DESIGN AND CONSTRUCTION MANUAL DESIGN MODIFICATION REQUEST

PROJECT NAME: The Retreat at Hook Farms 2nd Plat

Re: The Retreat at Hook Farms Second Plat-Stream Buffer Variance Request

STREAM BUFFER PLAN
 SITE GRADING & SITE DISTURBANCE PLANS
 THE RETREAT AT HOOK FARMS
 SECOND PLAT

SHEET
C500

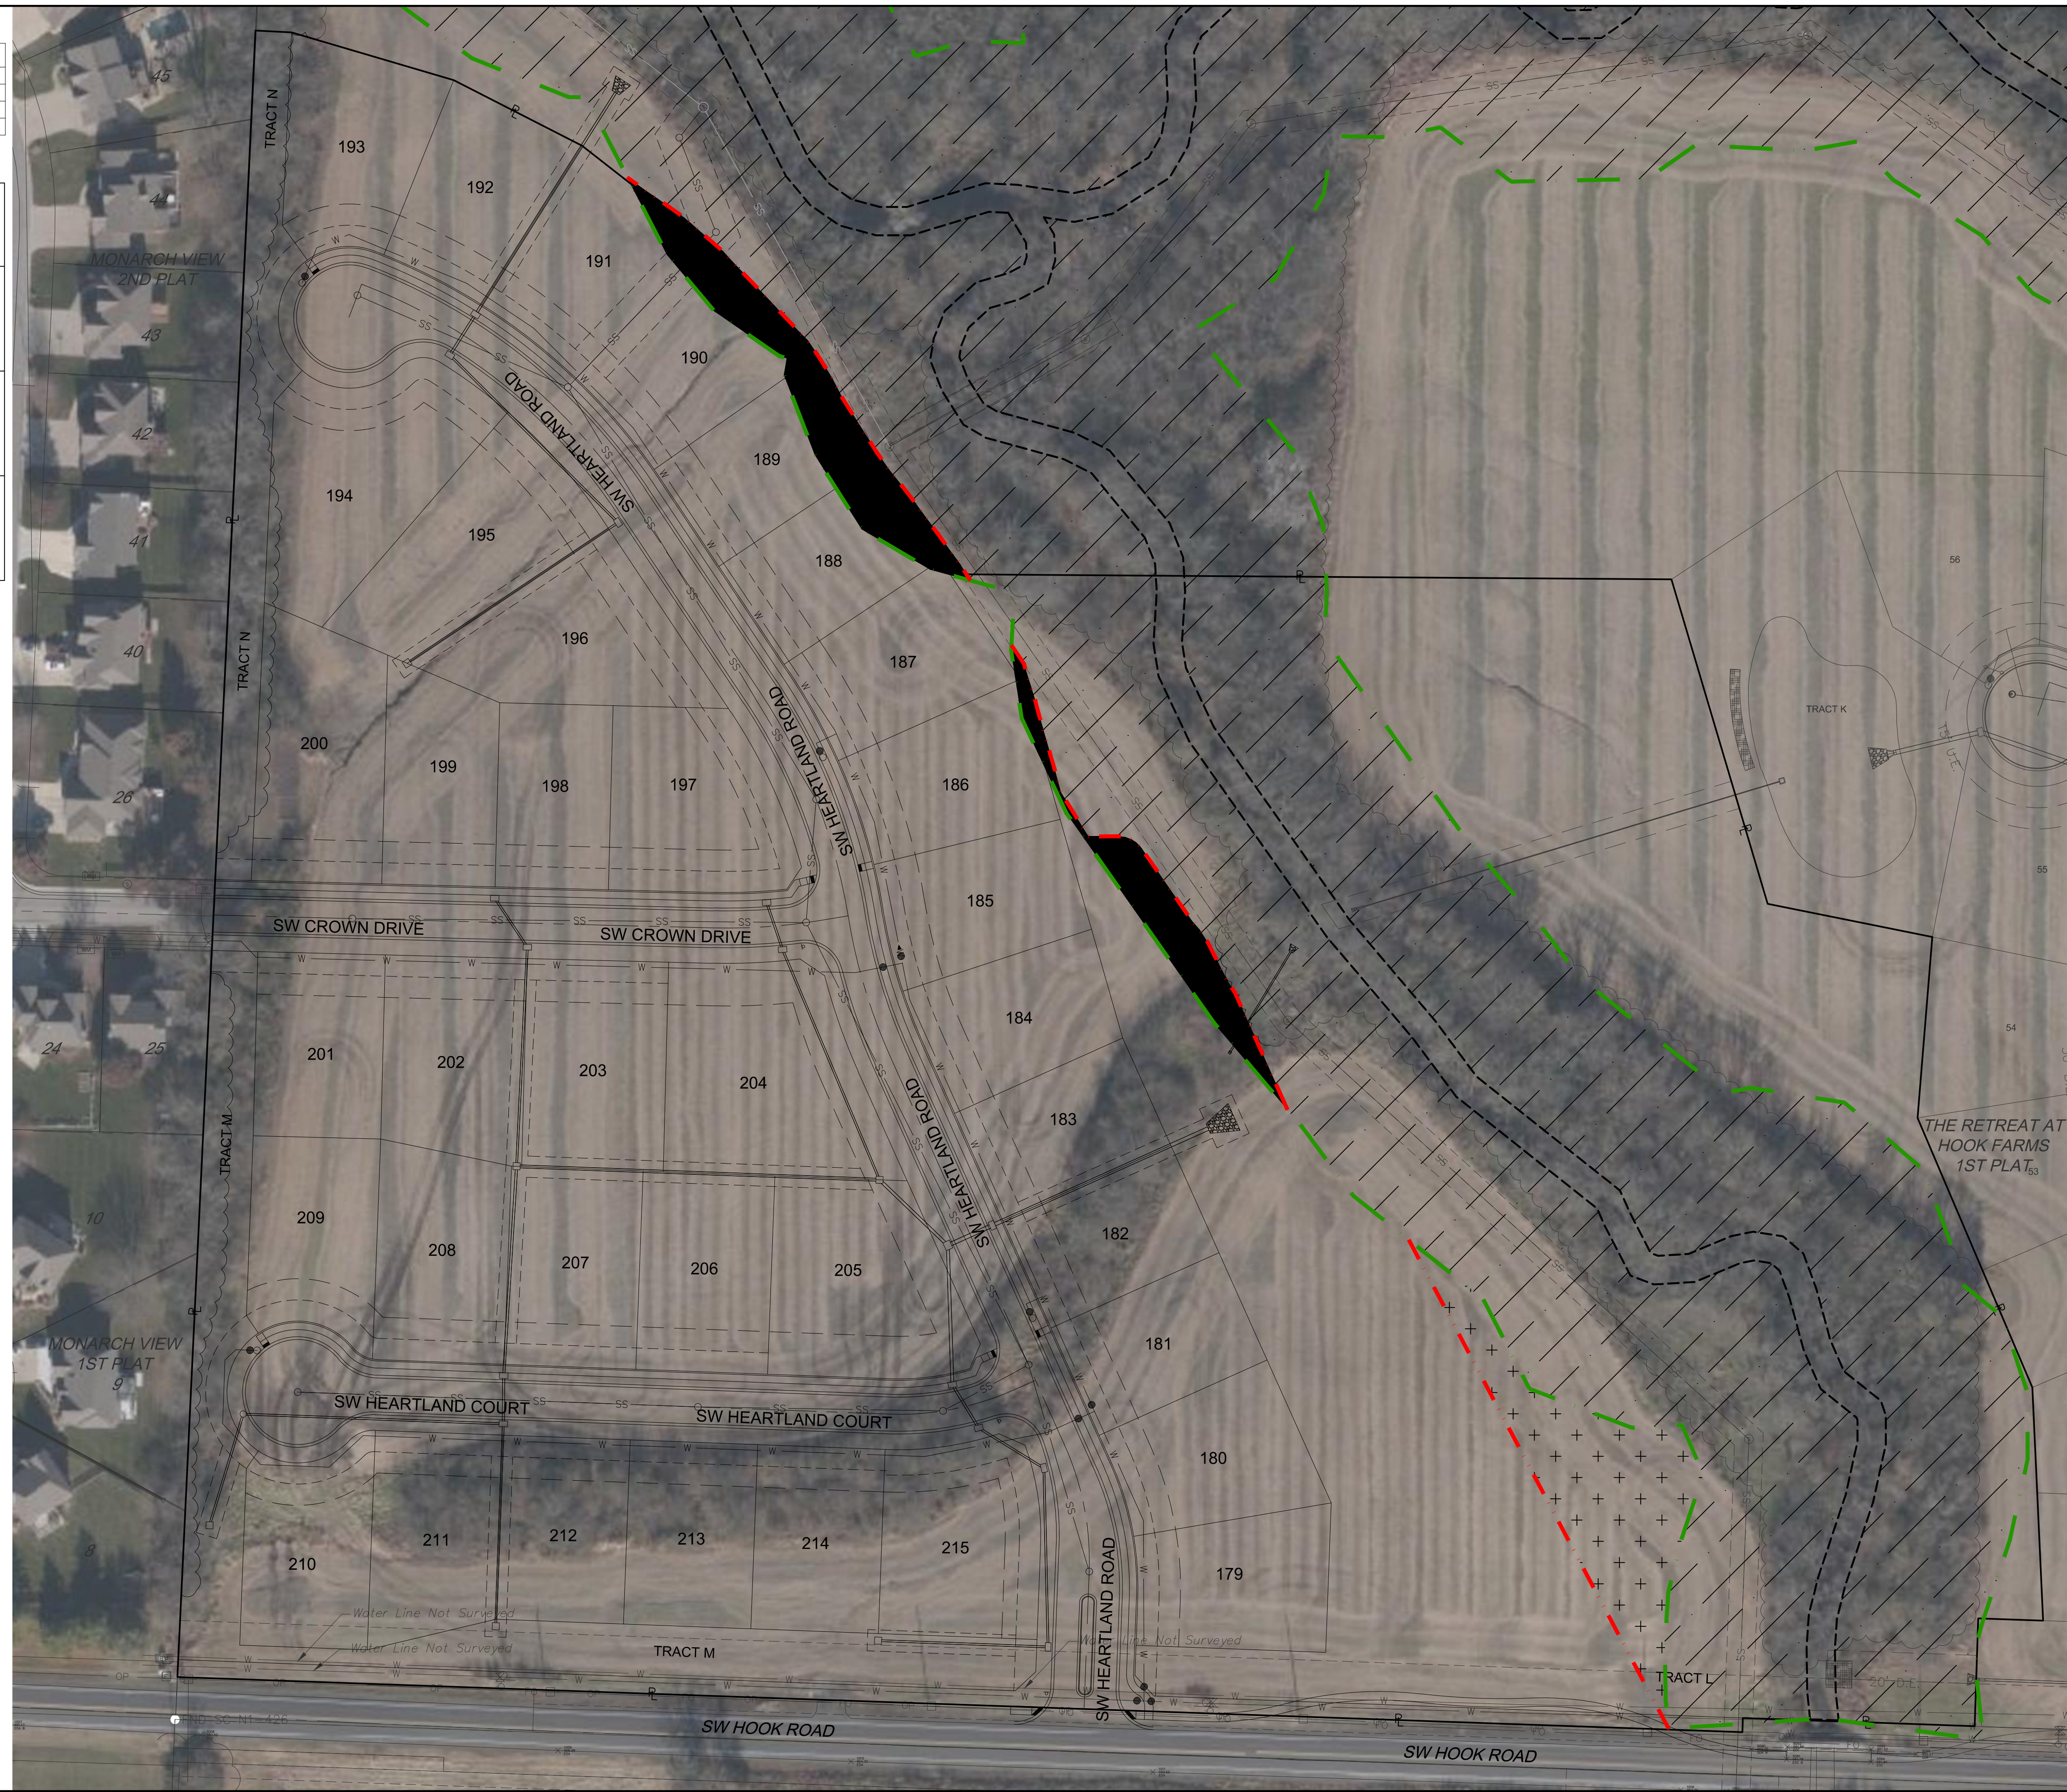
The stream buffer setbacks encroach on lots 186-191 of The Retreat at Hook Farms Second Plat. The city has requested an easement be placed over the stream buffer limits. From review of historic site imagery and site visits, this area has been under agricultural use for many years. Agricultural uses routinely disturb areas which prevents the growth of mature riparian vegetation. Due to the no active stream buffer existing in this area, we are requesting the setback zone be adjusted to remove the lot area and follow the rear lot lines.

While this request is asking to remove stream buffer setback zones, per the enclosed exhibit, this is limited to an approximate maximum setback distance of 35 feet, resulting in a total area of 0.378 acres. Areas outside of the shown disturbed limits, will maintain required setback distances and existing vegetation around the creek.

We are requesting the city approve with waiver/modification request to allow the final stream buffer setback to be reduced where it encroaches on lots, as shown in the attached exhibit. Shall you have any questions about this request please reach out to us at jsellers@olsson.com or 816.299.4340.
